Re: ***Addendum No. 1***
Minford Area Water Storage Tank
Scioto County Regional Water District No. 1

Date: February 6, 2024

1. SHEET 01C-02 – WATER STORAGE TANK PLAN & SECTION

NOTE:
1. TANK APPURTENANCES SHOWN MAY BE SHOWN OUT OF SECTION. REFER TO TANK SITE PLAN FOR ACTUAL ORIENTATION OF APPURTENANCES.

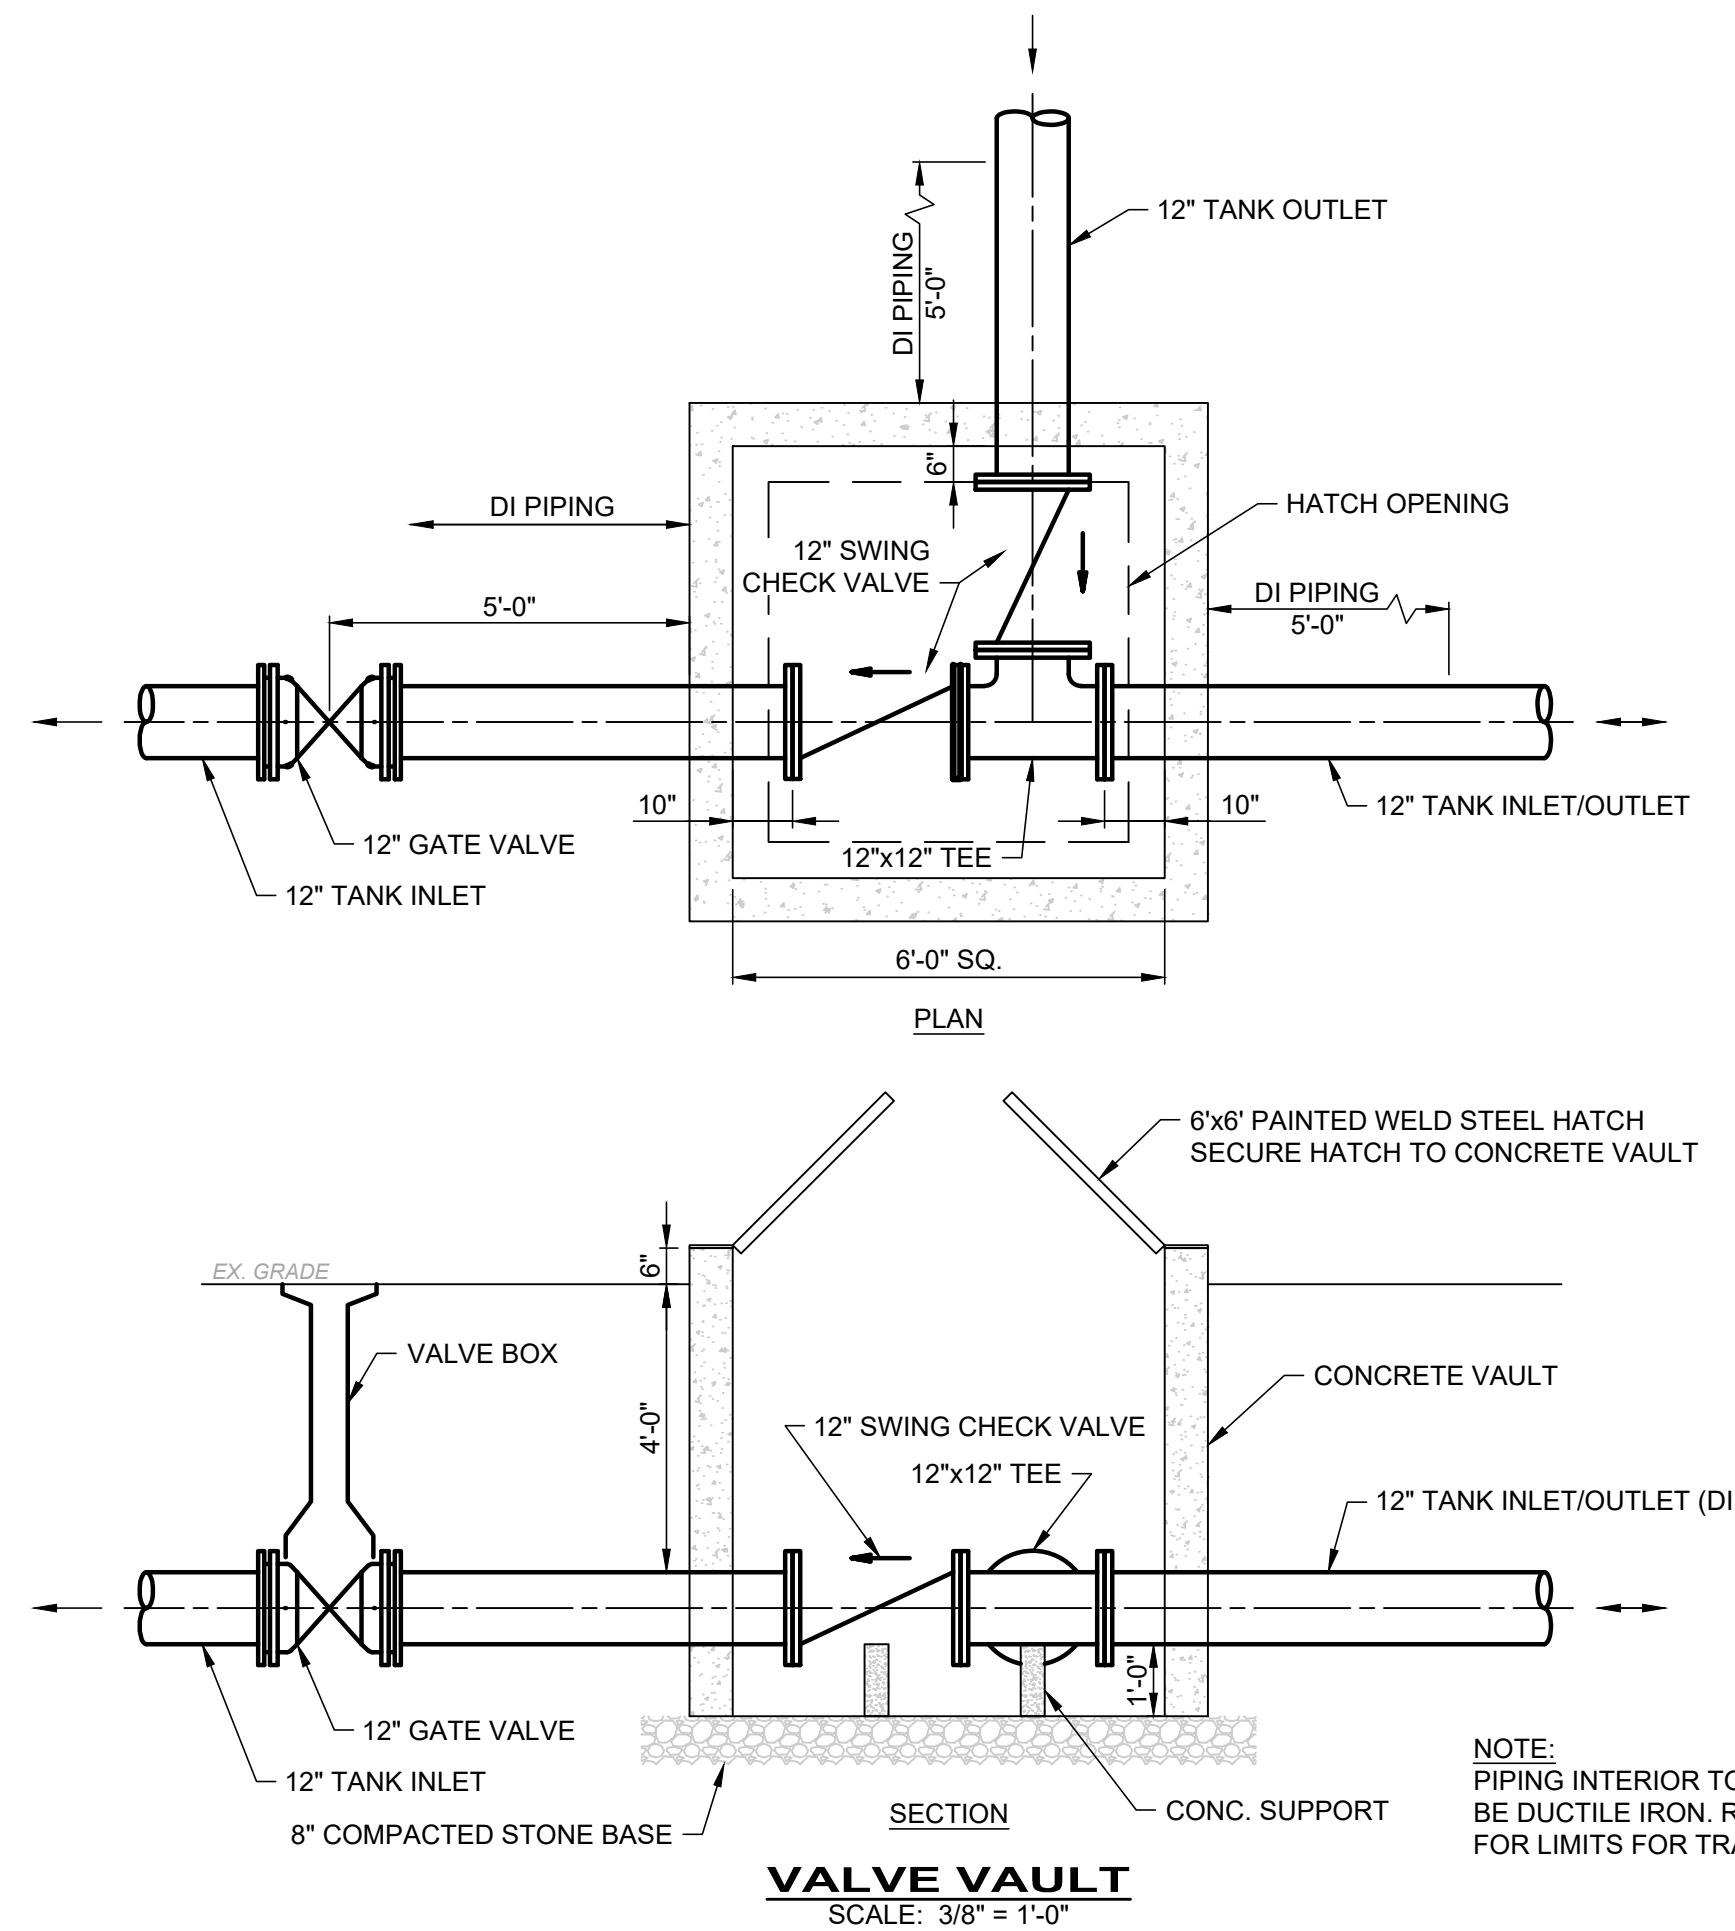
- a. **REPLACE** this drawing in its entirety with the revised drawing attached to this addendum.
